Point Pinos Trail Project

ADDENDUM NO. 1

Issued: Tuesday, May 26, 2020

7 AC PAVING
SCALE: 1" = 1' - 0"

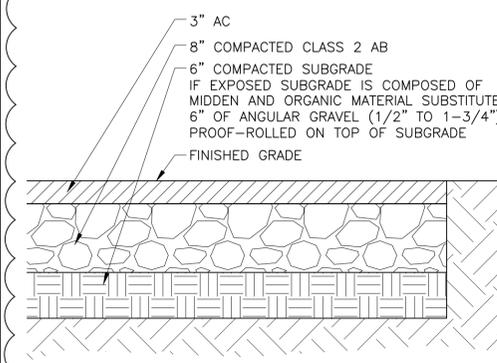
- 1) Revised Sheet 7.3, attached: Replace entire sheet, revised to include Detail 7, AC Paving.

- NOTES:
 1. AC PAVING AGGREGATE SHALL CONFORM TO THE GRADING SPECIFIED FOR 1/2-INCH MAXIMUM SIZE, MEDIUM GRADING.
 2. ASPHALT BINDER: PAVING GRADE OF ASPHALT SHALL BE DENSE GRADED, TYPICAL (PERFORMANCE GRADED) PG 64-10.
 3. CONTRACTOR SHALL SUPPLY OWN WATER.
 4. ALL COMPACTION 20 95%
